Flat C, 25 Fitzroy Square, W1T 6ER – Ref. 2021/0574/L

Delegated Re	port	Analysis sheet		Expiry Date:	01/07/2021	
(Members Briefin	ıg)	N/A / attached		Consultation Expiry Date:	11/04/2021	
Officer			App	lication Numbe	r(s)	
Rose Todd			2021	1/0574/L		
Application Address			Dra	wing Numbers		
Flat C, 25 Fitzroy Square W1T 6ER			Refe	er to Draft Decision	n Notice	
PO 3/4 Area Tea	m Signature	C&UD	Aut	horised Officer	Signature	
Proposal(s)						
Internal alterations and reorganisation of layout including relocation of internal entrance to the flat onto the shared stairwell at first floor level. Reopening of the original doorway into the living room from the hallway and creation of WC at first floor. Replacement of internal staircase from first to second floor (Class C3).						
Recommendation:	Grant Listed	l Building Consent				
Application Type:	Listed build	ing consent

DECISION

Listed Building Consent Granted

3. Proposed stair to replace the existing 1980s staircase.

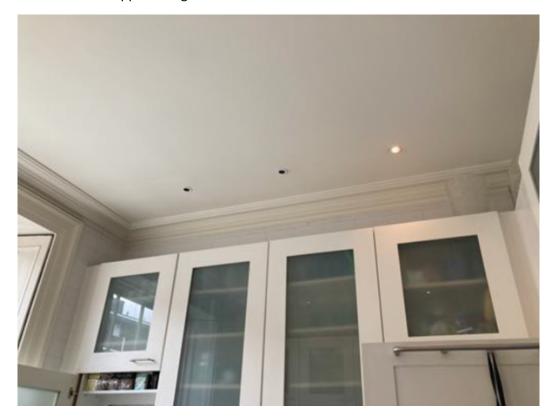
- 4.5. The design details of all new doors and the new staircase have been conditioned to ensure that the architectural significance of the listed building is both preserved and enhanced.

- Detailed drawings, or samples of materials as appropriate, in respect of the following, shall be submitted to and approved in writing by the local planning authority before the relevant part of the work is begun:
 - a) Plan, elevation and section drawings of all new doors at a scale of 1:10 with typical moulding and architrave details at a scale of 1:1.
 - b) Plan, elevation and section drawings of the new staircase and handrail at a scale of 1:10.
